**Response to Independent Planning Commission
Request for Additional Information
Gazcorp Industrial Estate (SSD 5248)**

Attachment 1 Response to Independent Planning Commission Request for Additional Information

Figure 1 | Oakdale South Estate Setback from future SLR

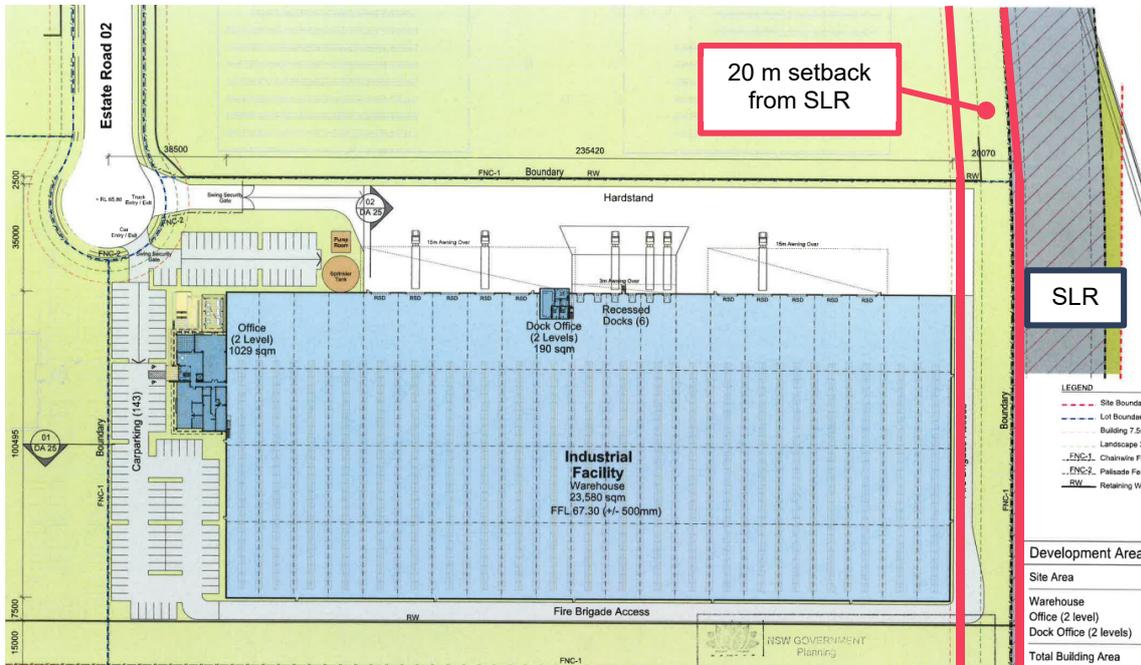
The table above shows the proposed development controls for the Gazcorp Industrial Estate are consistent with other developments in the WSEA except the setback from the future Southern Link Road (SLR). This departure is due to the way the setback is measured. As shown in the figures below, the Oakdale South and Oakdale West Estates measure the SLR setback from the external walls of the future warehouse buildings, whereas Gazcorp Industrial Estate measured the SLR setback from the future lot boundaries.

Figure 3 | Gazcorp Industrial Estate

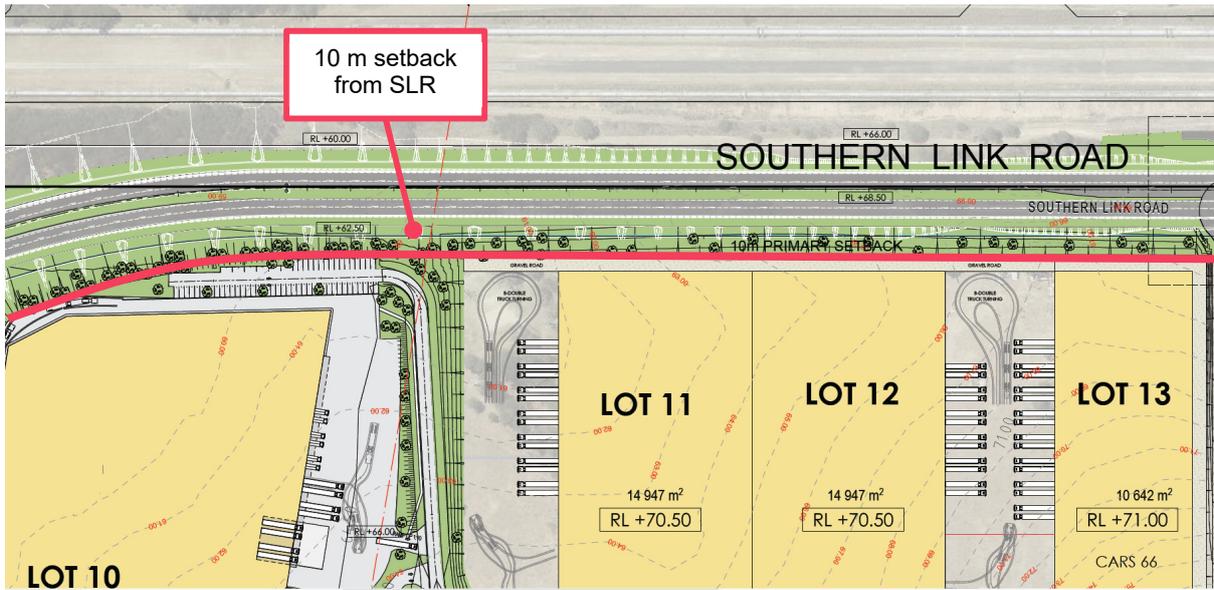
The Department notes the SLR would be a four-lane road (two lanes in each direction) and will include batters on the edges of the road. TfNSW is presently finalising the detailed design of the SLR. The proposed 10 m SLR setback is required to ensure the Gazcorp Industrial Estate development will not encroach into the SLR reserve, to ensure there is sufficient flexibility and room for TfNSW to finalise the final SLR alignment. The Stage 1 Building and all future warehouse buildings are also required to have additional setbacks of at least 6 m from the lot boundaries to provide access for firefighting vehicles, compliant with FRNSW *Guidelines for Emergency Vehicle Access 2010*. This access would also need to consider the setback requirements for the future SLR.
